Re Garvies Point Waterfront Mixed-Use Development
Second Amended PUD Master Development Plan and
Phase IIB D-E-F Site Plan
March 2021 Submittals

This letter has been prepared to address the review memo dated April 27, 2021 from Mr. Robert G. Nelson, Jr., P.E. of Nelson + Pope (N+P No: 15122). Please note that the order of our responses follows the order of the original comments, and we have included the original comment followed by our response in ***bold italics***.

Garvie's Point - Block A Parking Overlay
NTS

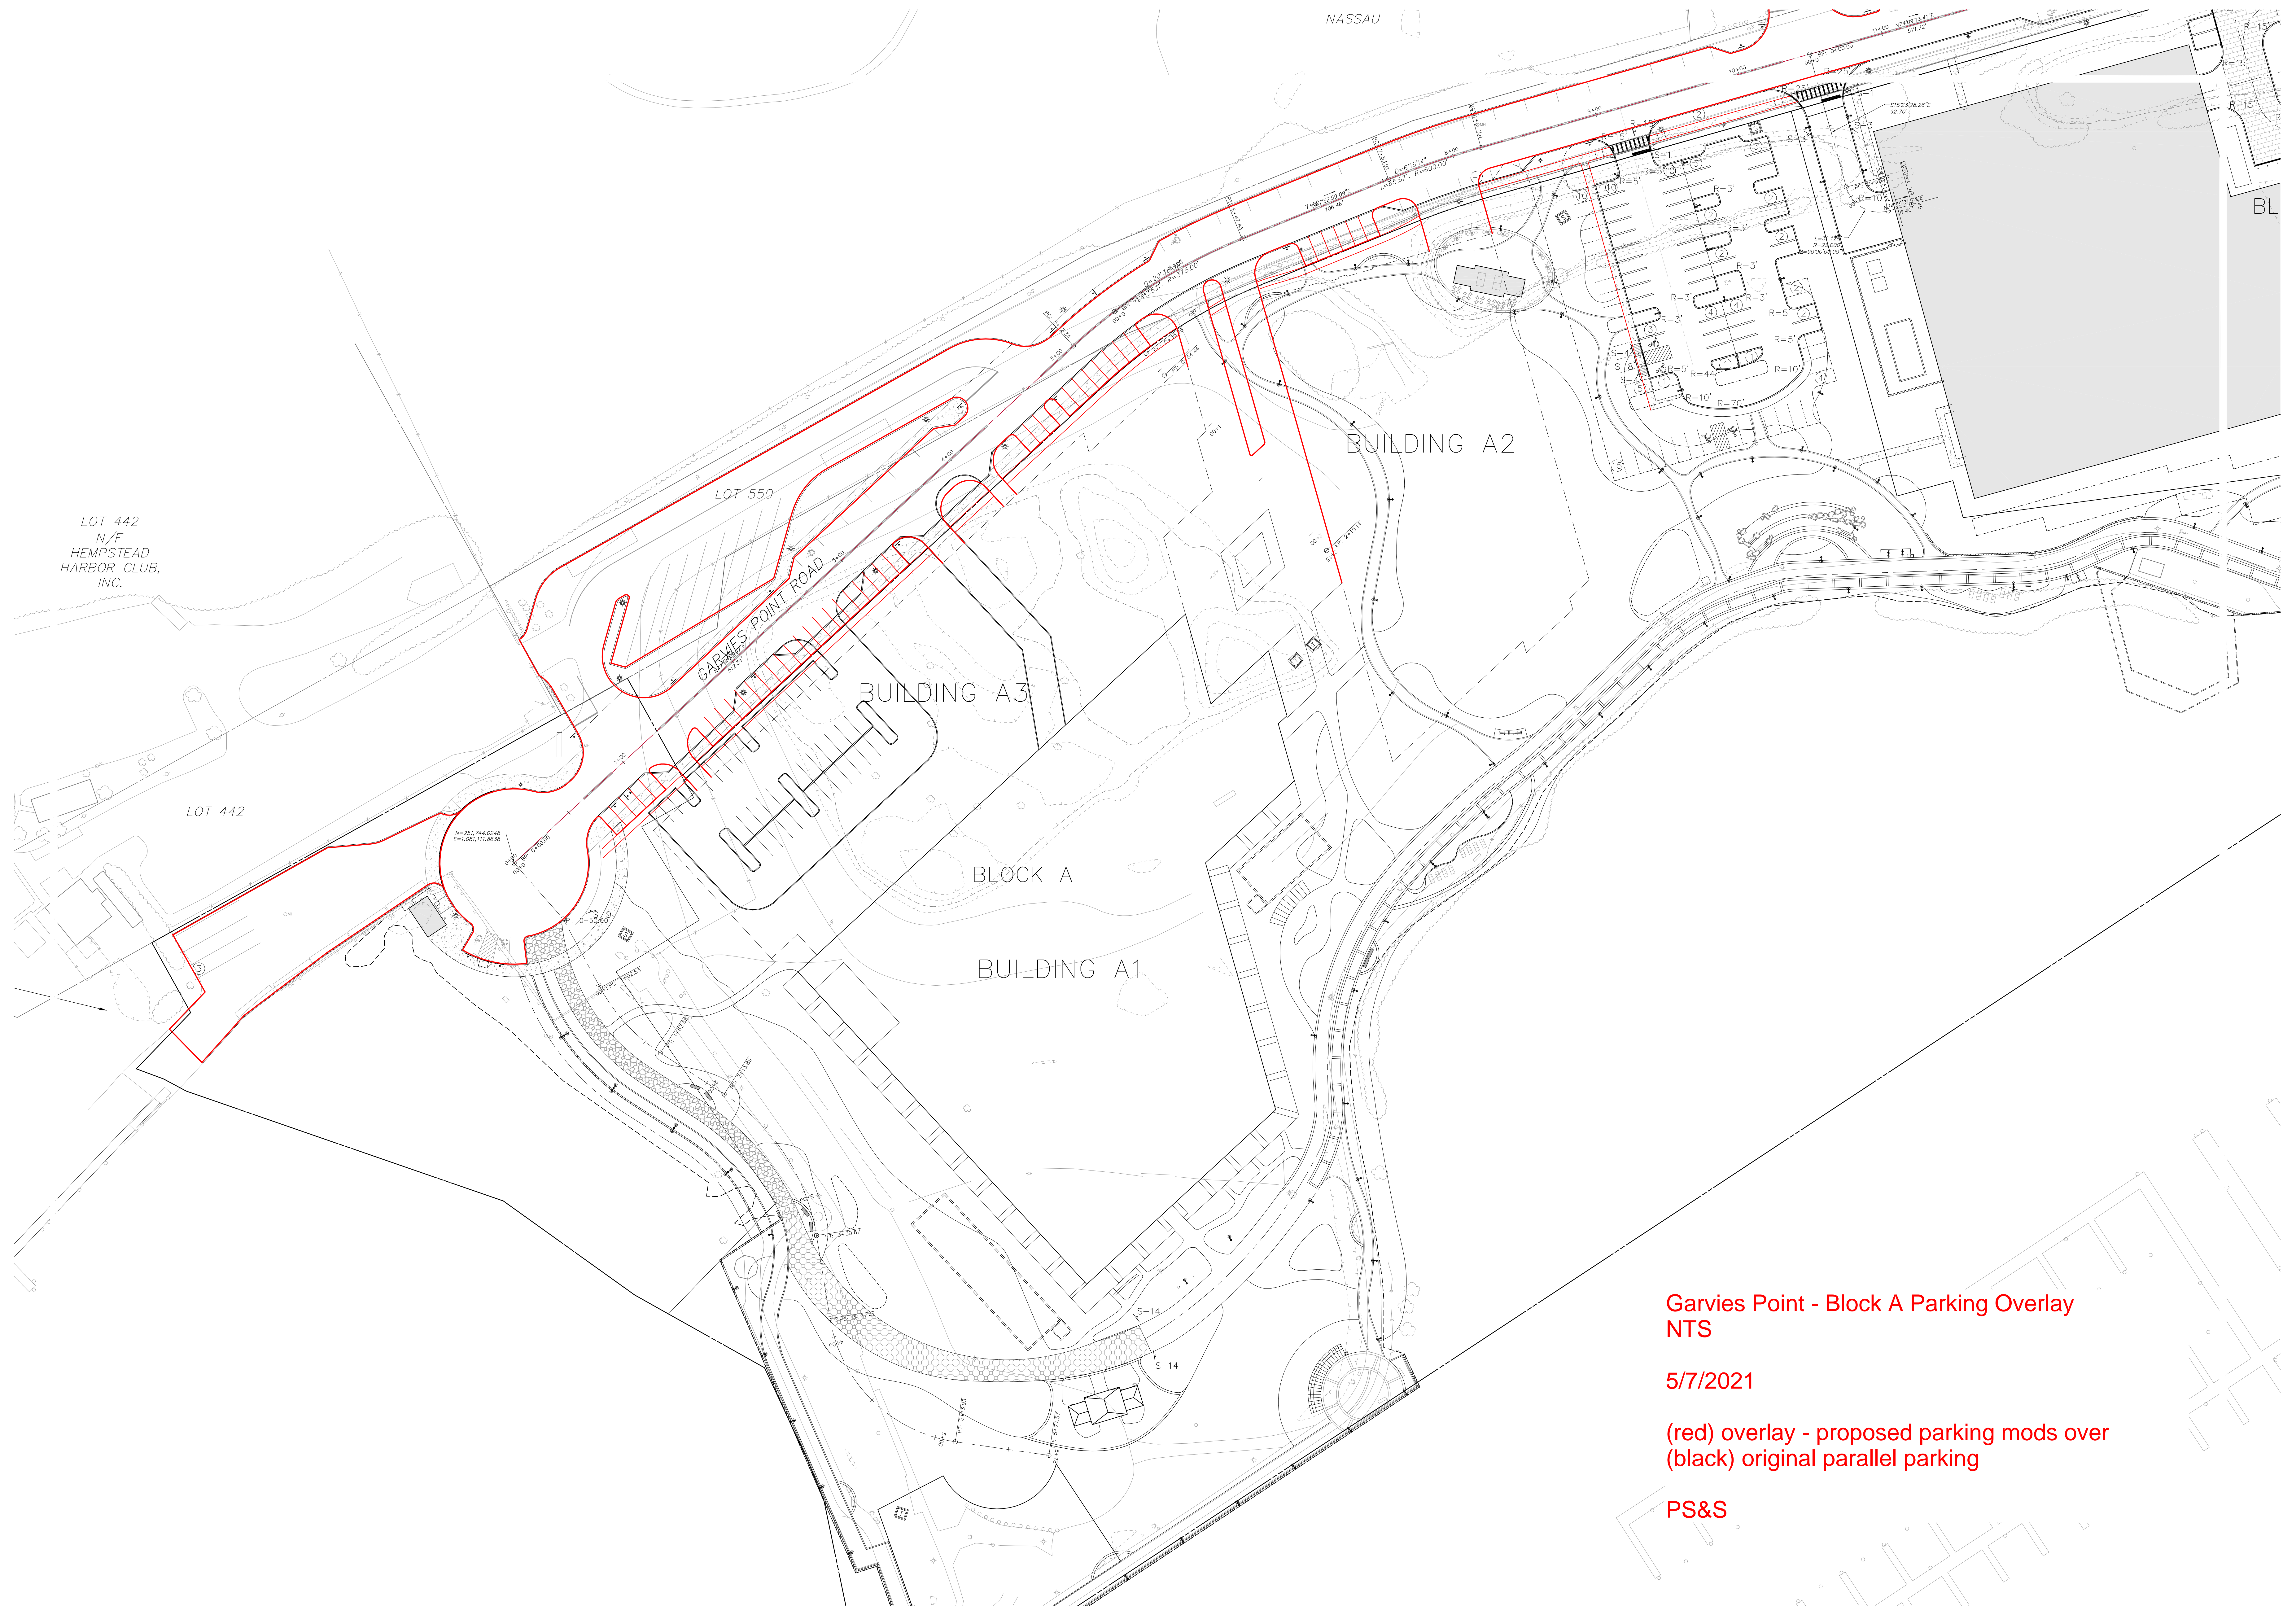
- The parking analysis references the reconfigured stalls as “angled” but in Attachment A the stalls are shown as perpendicular to the sidewalk. The configuration of the stalls need to be clarified.

- The stall reconfiguration in relation to the Garvies Point ROW and travel lanes is necessary to determine if the stalls encroach into the travel lanes or over the ROW line. The stalls should not reduce the State approved travel lane width. If stalls encroach over the ROW line in the PUD boundary, a ROW widening may be required.

- The on-street parking configuration needs to be depicted consistency on all the submitted documents.

RESPONSE: The proposed new on-street parking layout will be perpendicular to the sidewalk as shown on Attachment A.

RESPONSE: We have confirmed that the proposed new on-street parking layout will not encroach into the travel lanes as originally designed, nor encroach over the ROW. The proposed sidewalk will be located within the Block A site. Please see Attachment A.

RESPONSE: The proposed new on-street parking will be consistent on all submitted documents. See Memorandum from Walker Consultants.

**FIRE TRUCK
MOVEMENT PLAN**

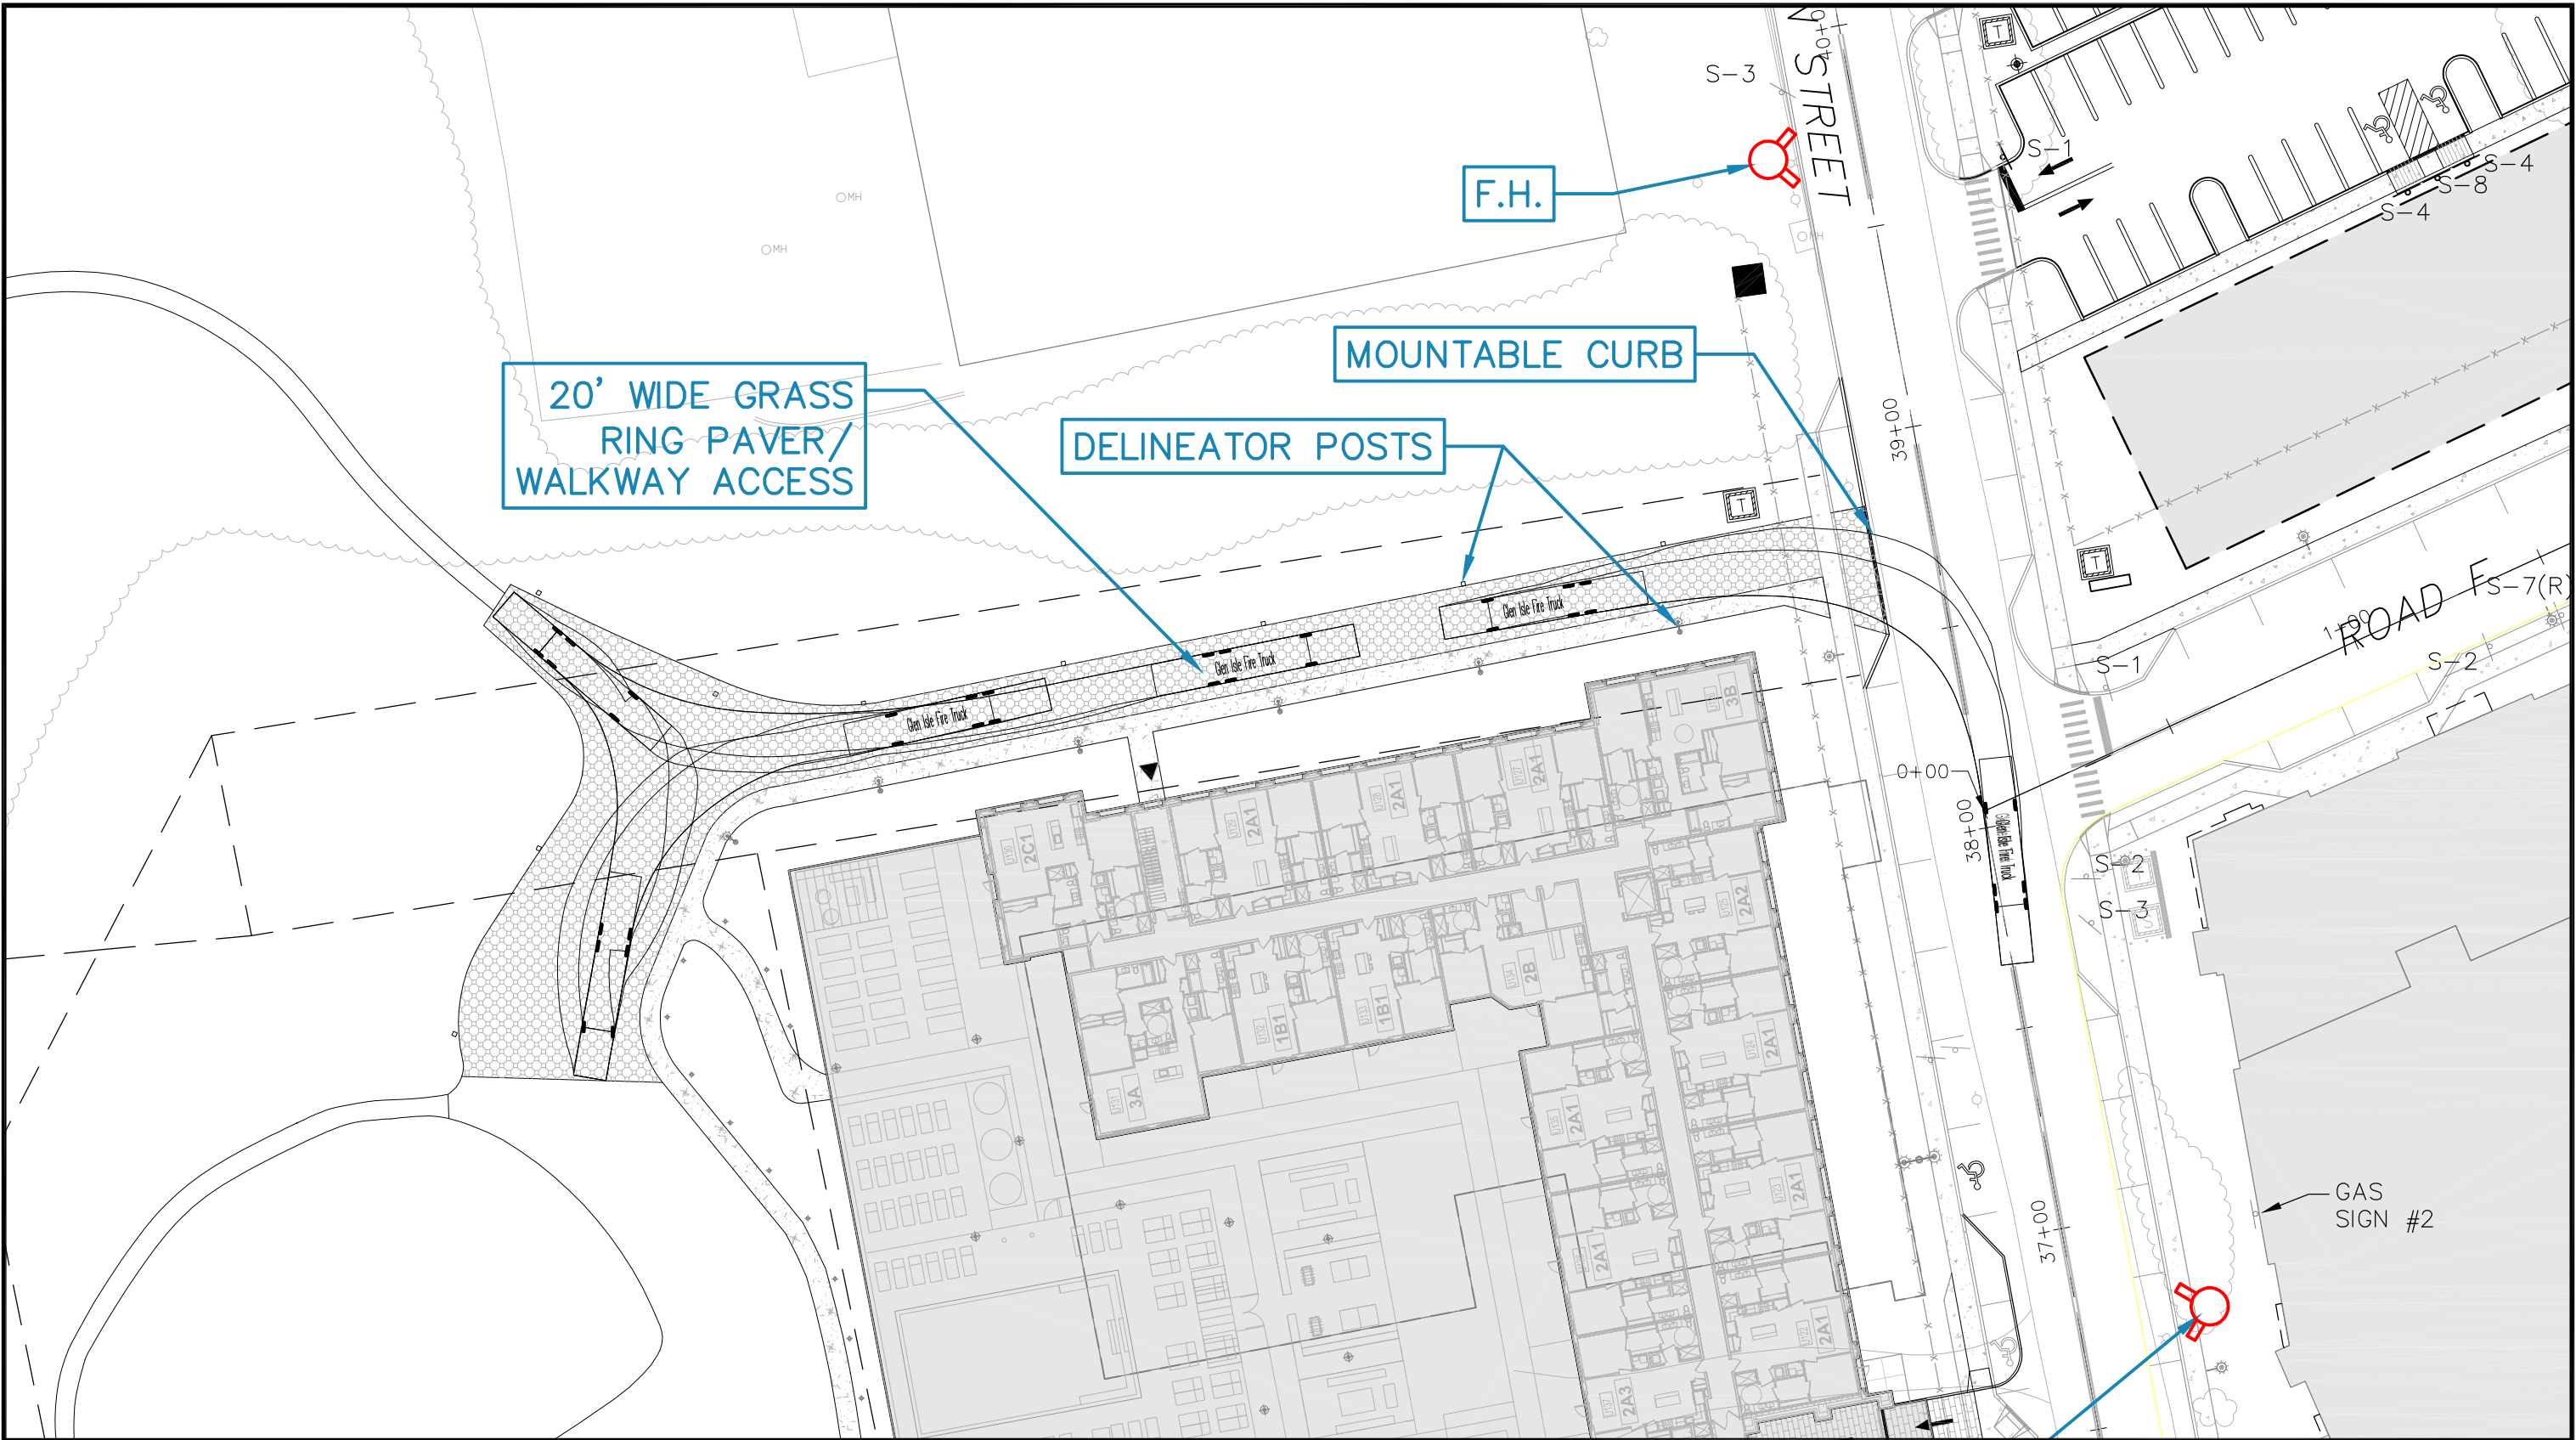
A review of the revised plans indicates there may be a "hammerhead" proposed for the emergency vehicle access route. A hammerhead is one of the techniques available to provide for an emergency vehicle, i.e. fire apparatus, the ability to turn around when the emergency access route is longer than 150-ft from the nearest roadway. The hammerhead and emergency access road should be more clearly defined and include dimensions, route

delineations, signing and detailing to show compliance with the NYS Fire Code.

RESPONSE: The plans will be revised to clearly depict the "hammerhead" proposed for the emergency vehicle access route. The associated dimensions, route delineations, signing and detailing will also be provided. See attached exhibit showing the configuration as well as the fire truck turning maneuvers.
